CHANNELL CAMPUS IMPROVEMENTS

SP2021-011; Administrative Review - Site Plan for Channell Campus Improvements

PROJECT NUMBER: SP2021-011
PROJECT NAME: Amended Site Plan for Channell Commercial Corporation
SITE ADDRESS/LOCATIONS: 1700 JUSTIN RD, ROCKWALL, 75087

CASE CAPTION: Review a request by David Meinhardt of Meinhardt & Associates, PLLC on behalf of Ed Burke of Channell Commercial Corporation for the approval of an Administrative Site Plan for the construction of an industrial building on an 18.762-acre parcel of land identified as Lot 2, Block A, Channell Subdivision, City of Rockwall, Rockwall County, Texas, zoned Light Industrial (LI) District, situated within the SH-205 By-Pass Overlay (SH-205 BY OV) District, addressed as 1700 Justin Road, and take any action necessary.

**ALTERNATE LANDSCAPE PLAN WEST
CHANNELL COMMERCIAL CORP.
WEST PARKING & STORAGE LAYOUT
1700 JUSTIN ROAD
CITY OF ROCKWALL, ROCKWALL COUNTY, TEXAS**

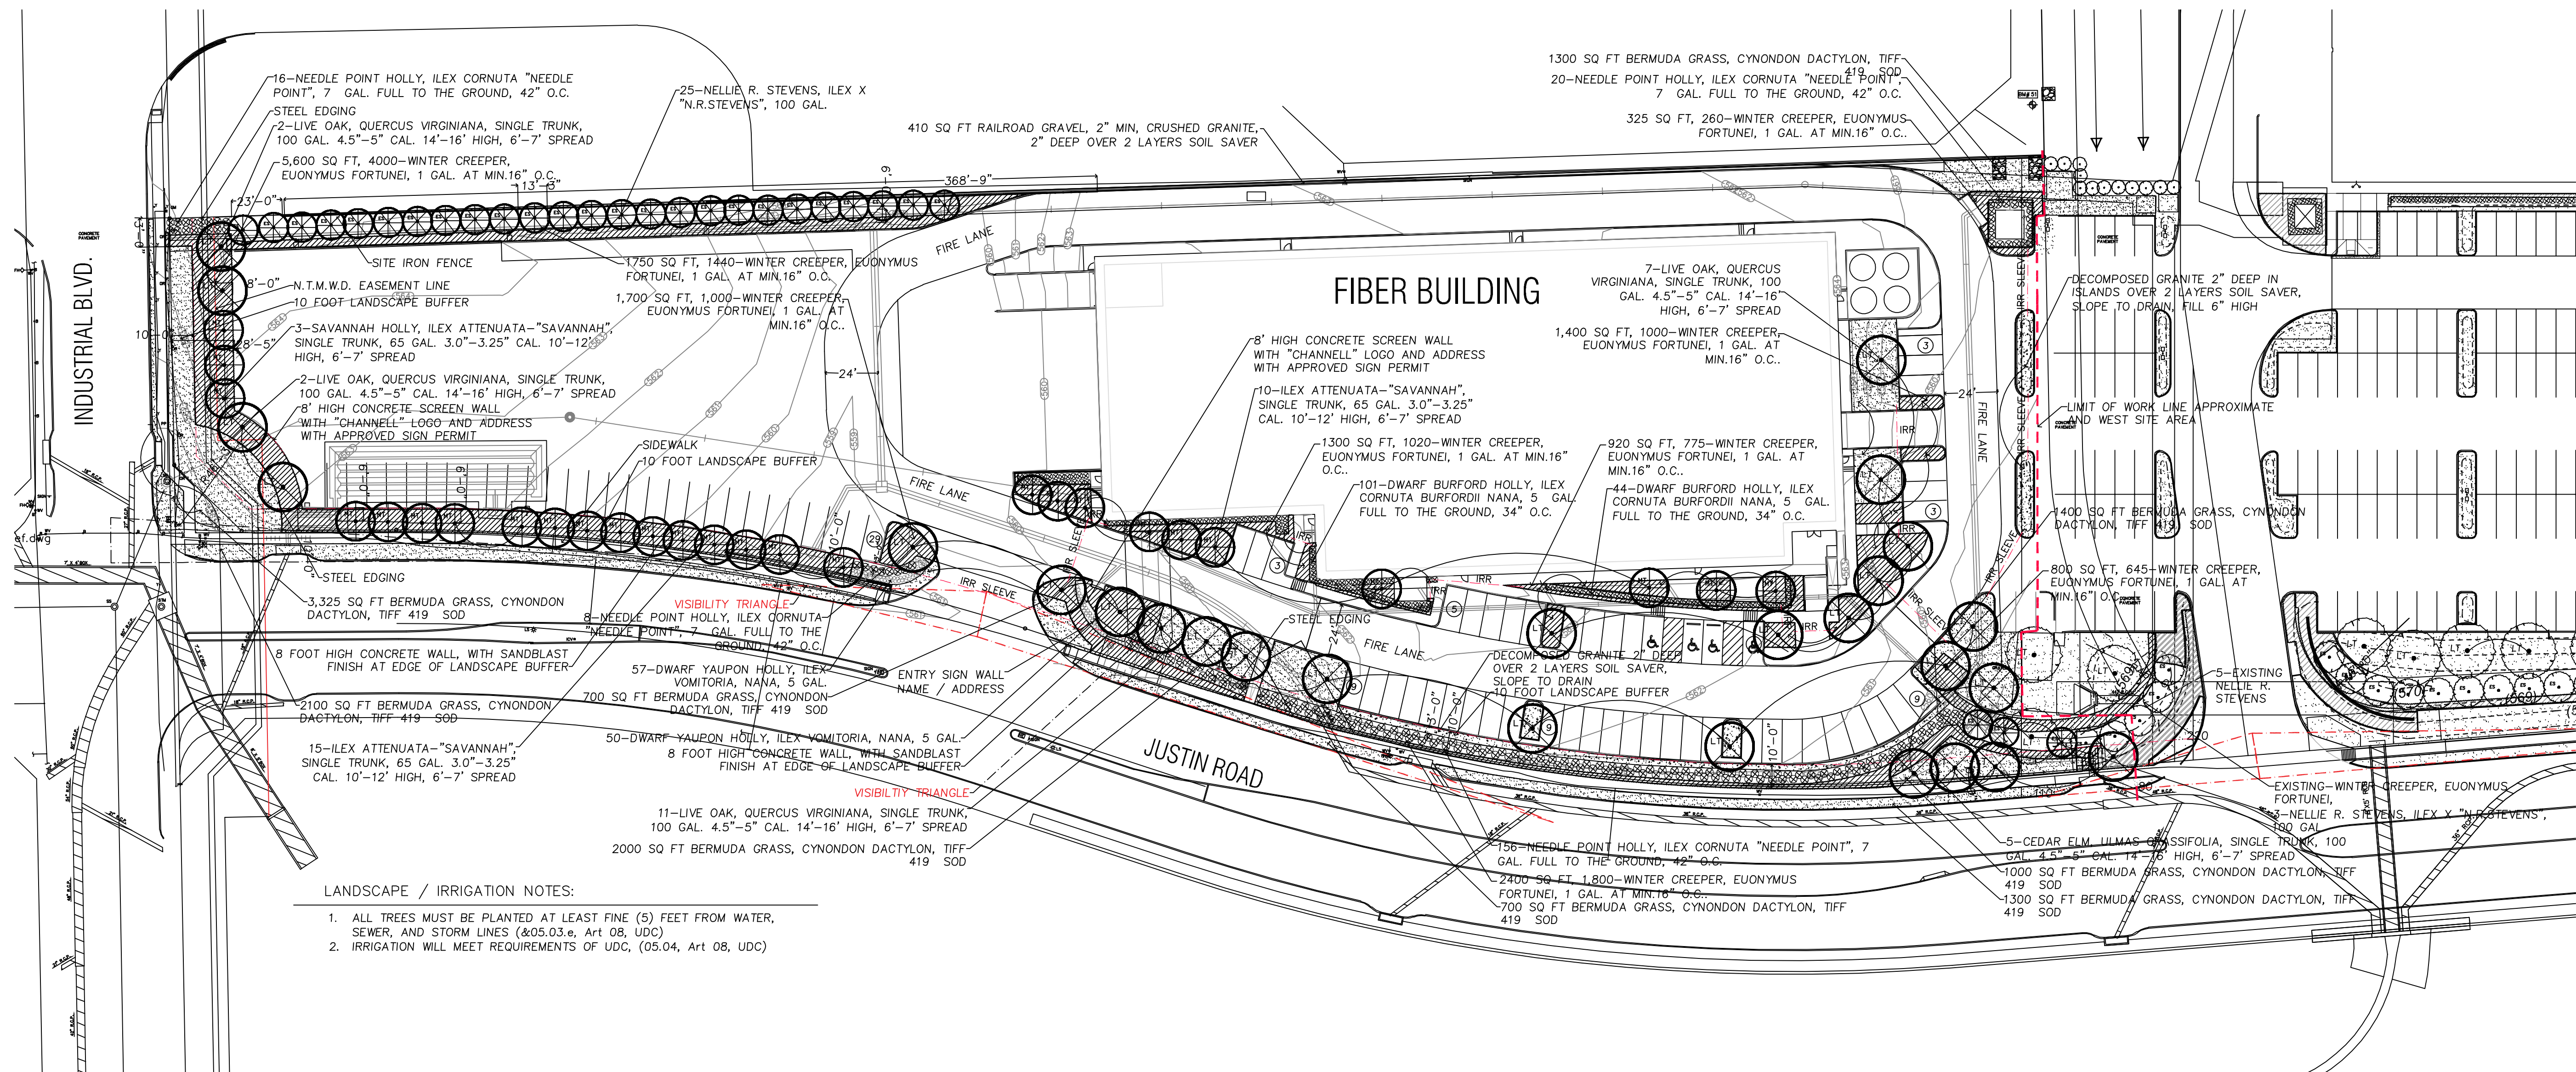
- 1) Verify count of Nellie R. Stevens adjacent to northwest property line where screening fence is being placed (i.e. 26 labeled, 25 counted) and number of Savannah's where new building located (i.e. 11 labeled, 10 counted). Correct plans.

(*) STREET TREES EXTEND INTO THE ADJACENT LANDSCAPE AREA BETWEEN STREET AND PARKING EDGE.
(1) 2 SAVANNAH HOLLY REMOVED DUE TO UNDER GROUND UTILITIES

NO.	DATE	REVISION
LA-1	04/30/2021	REVISED PLANT COUNT PER CITY COMMENTS
LA-1	05/13/2021	RELOCATED AND REMOVED TREES PER CITY COMMENTS ADDED TREE ROOT BARRIER NOTE TO THE PLAN.

PROJECT NO: 20-205
 DATE: 04.09.2021
 DRAWN BY: DBC
 CHECKED BY: DDM
 SHEET: SITE PLAN

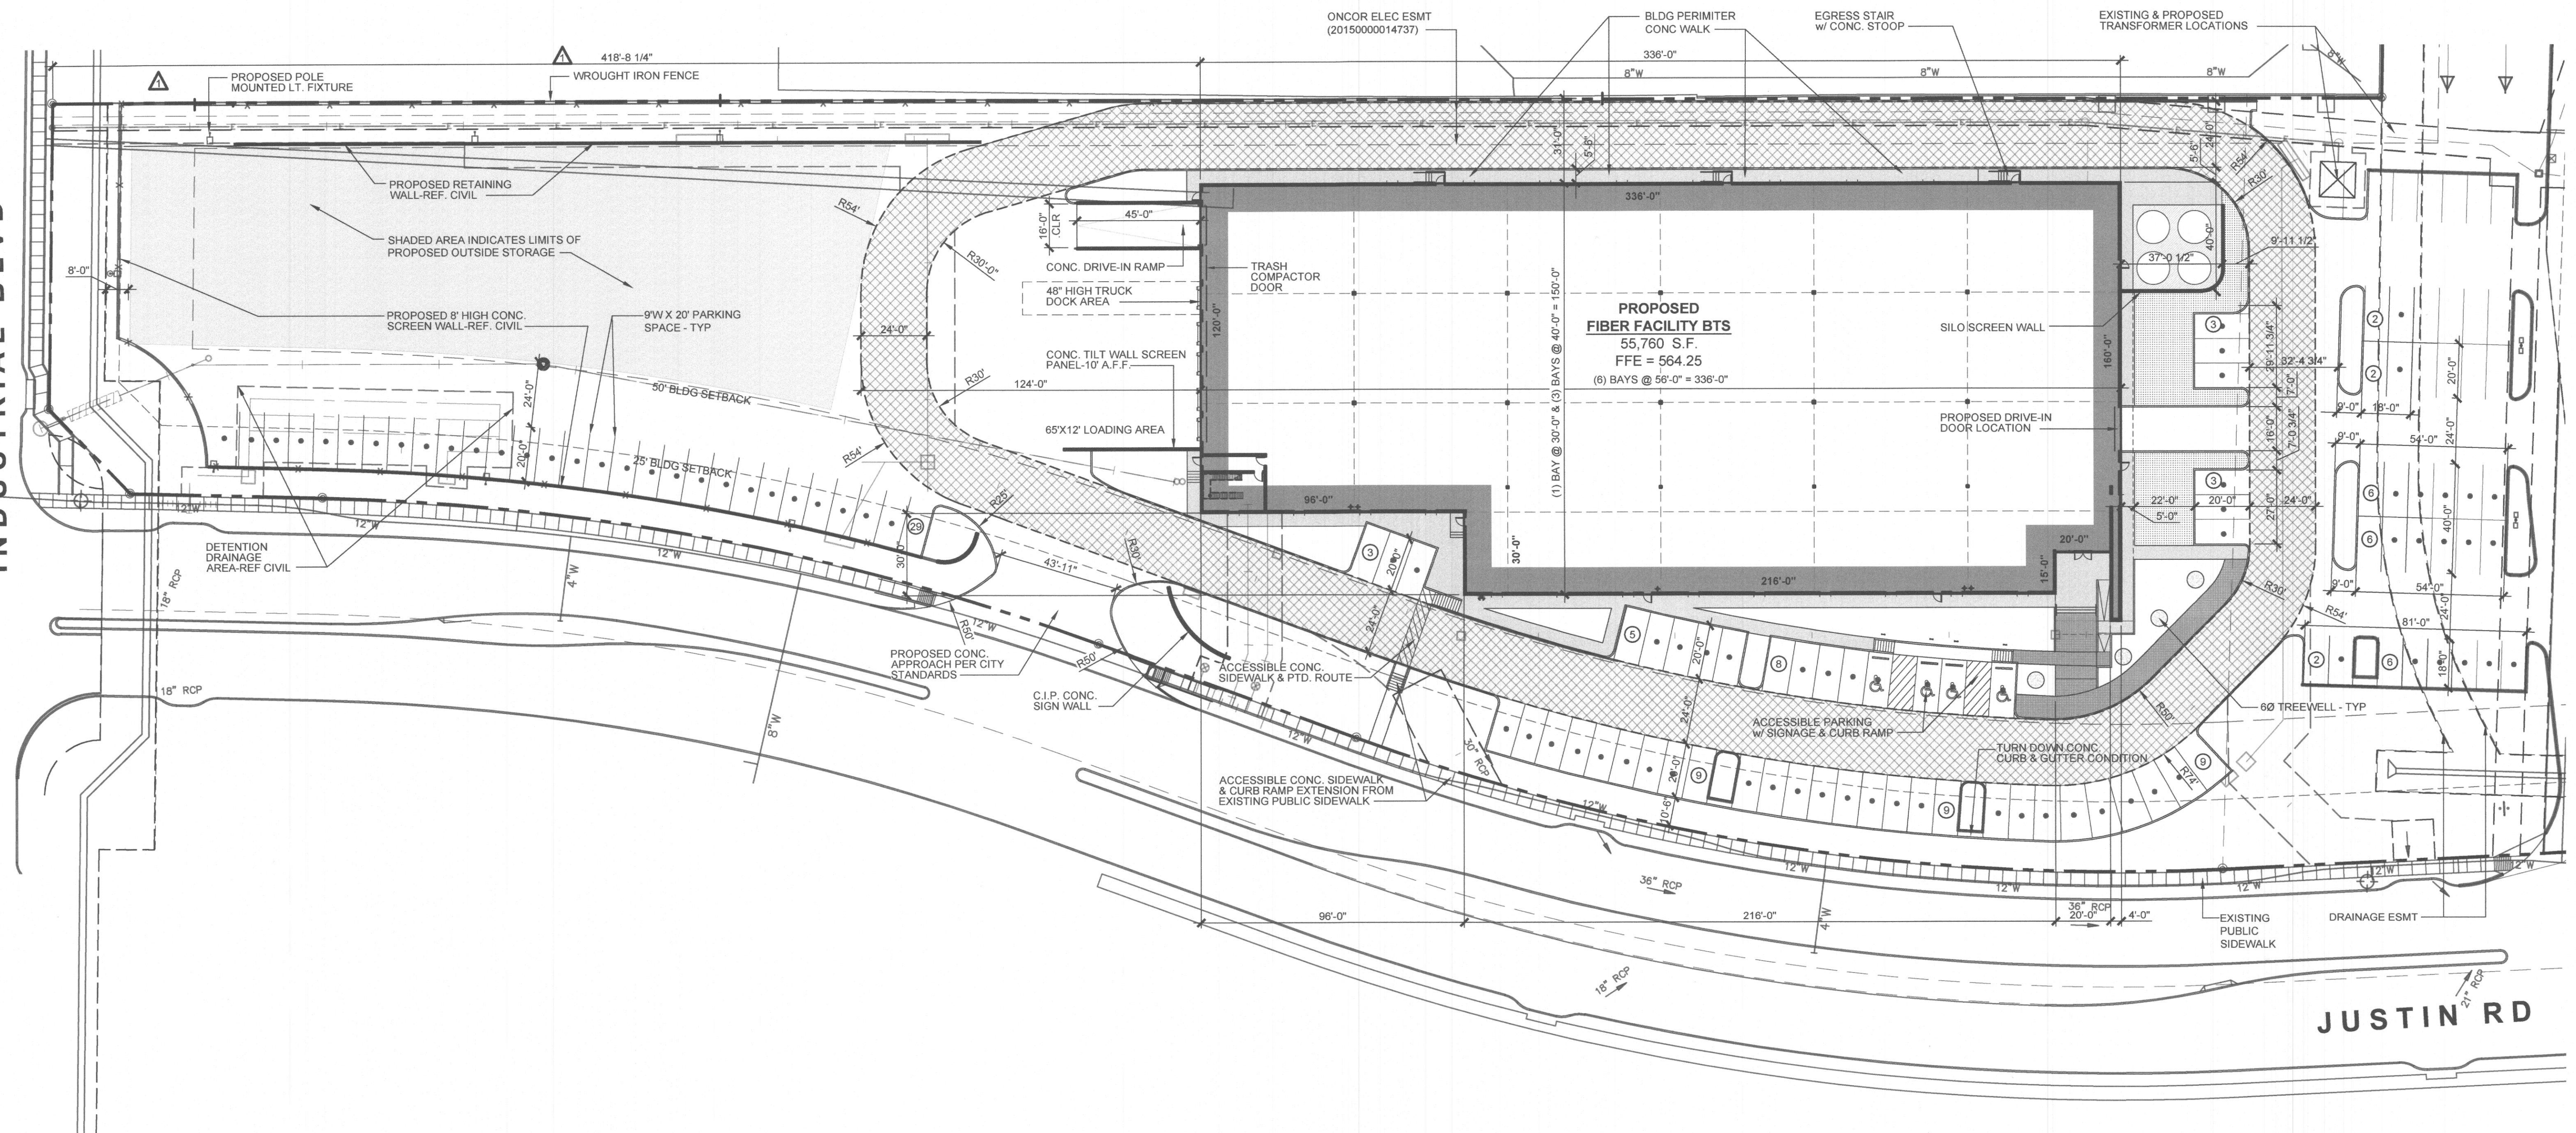
- 1) Under Total Improvement Area, make the following corrections:
 - a. Total parking required, remove the label "per 11/20/2020 comments", provided parking meets the technical requirements.
 - b. Remove the "Occupant Load" data in this section. This is a building code requirement at the time of building permit and not to be included with this site plan.
- 2) Verify parking count and relabel all parking counts that are not correct (i.e. 29 = 28 spaces, etc.). Are all parking spaces being counted (i.e. east side parking area missing labels)?

01 SITE PLAN - PHOTOMETRIC
 SCALE: 1" = 60'-0"
 GRAPHIC SCALE IN FEET

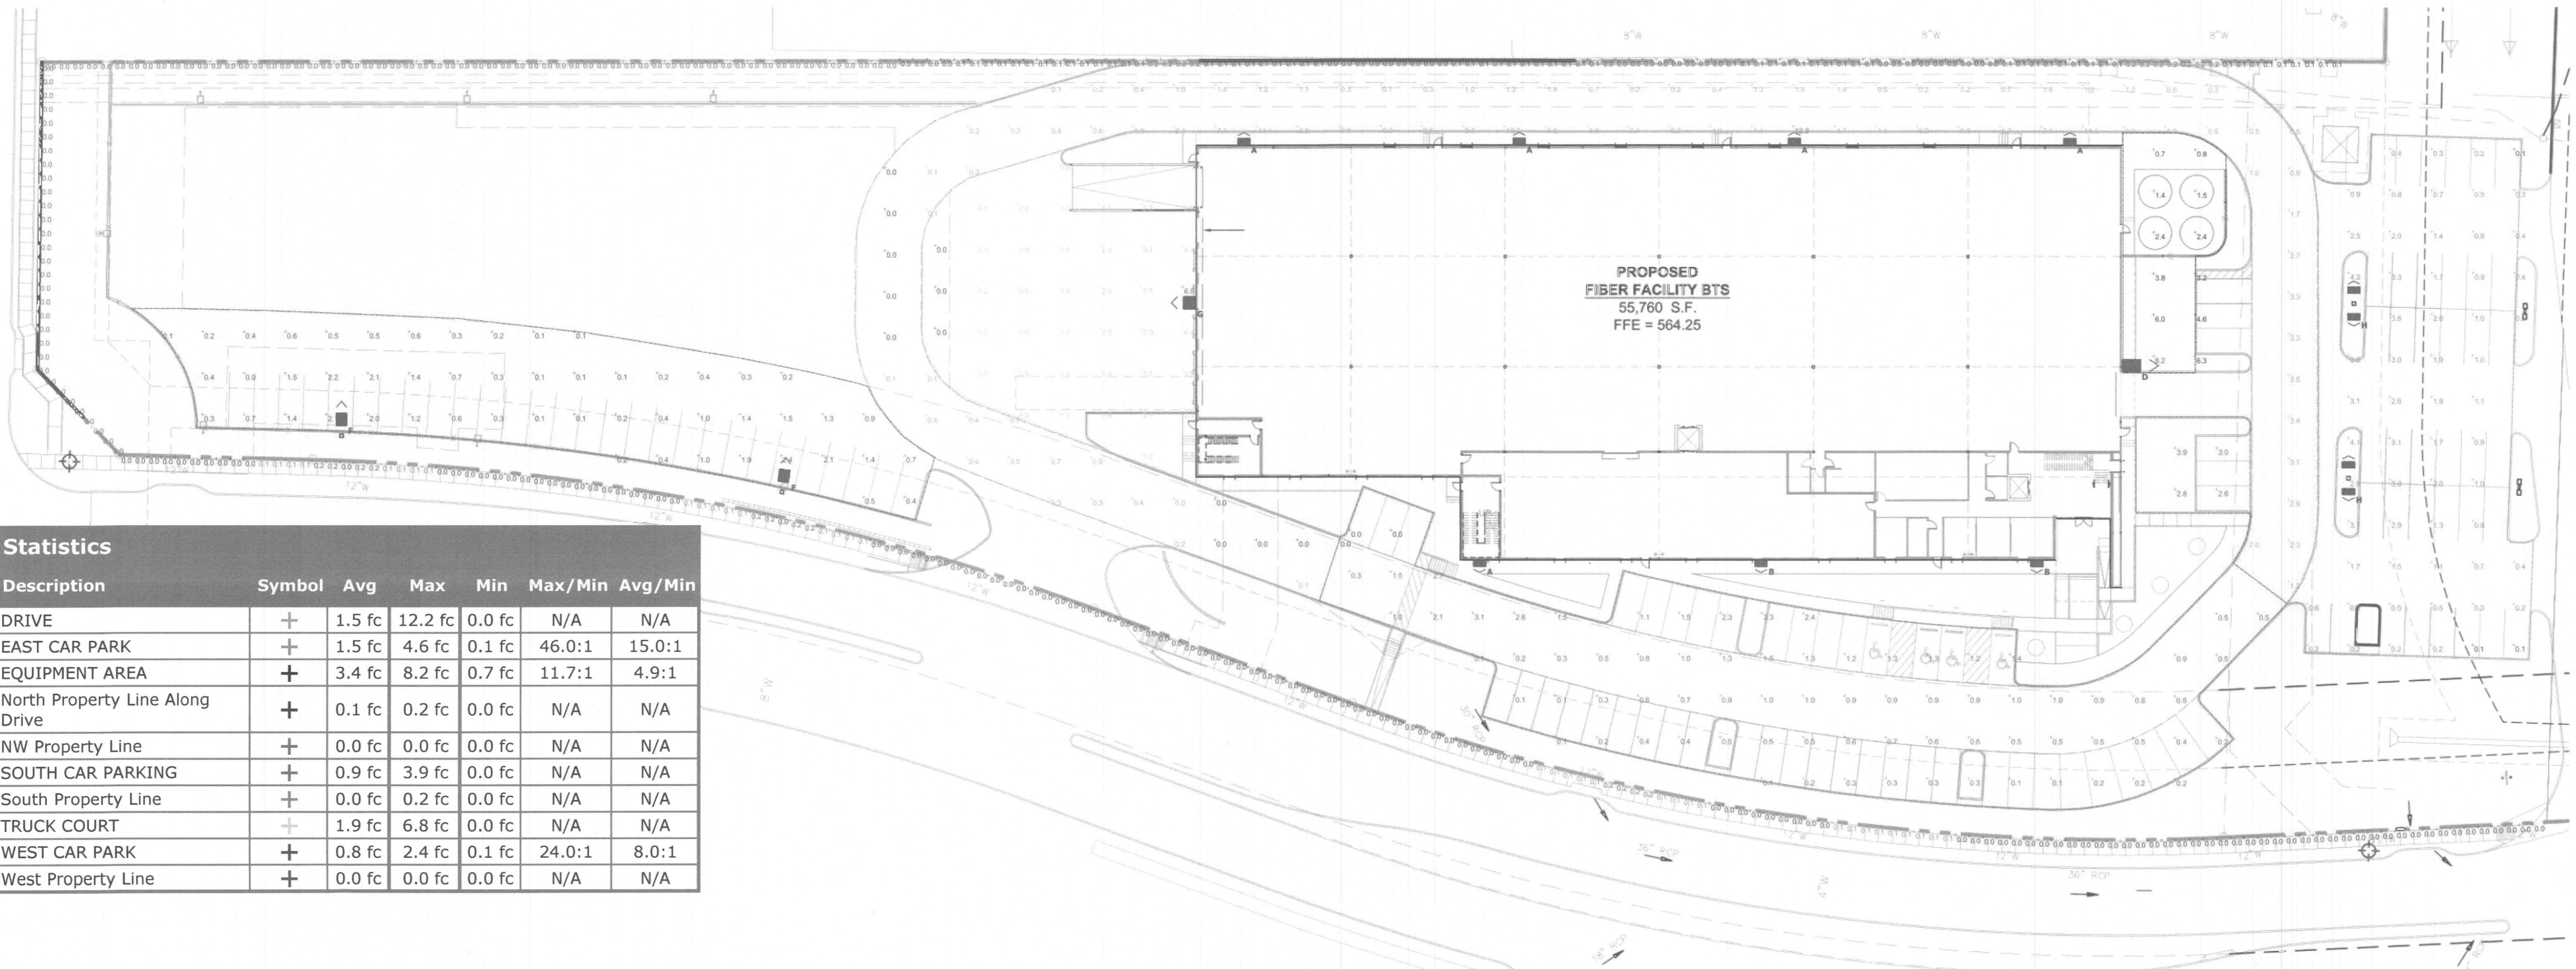
- 1) Provide cut sheets for all exterior lighting fixtures. (§03.03, Art. 07,UDC)
- 2) Revise plans and provide readings all the way to the property lines for review. The maximum lighting levels are not to exceed 0.2-FC at the property lines. (§03.03(C), Art. 07,UDC)
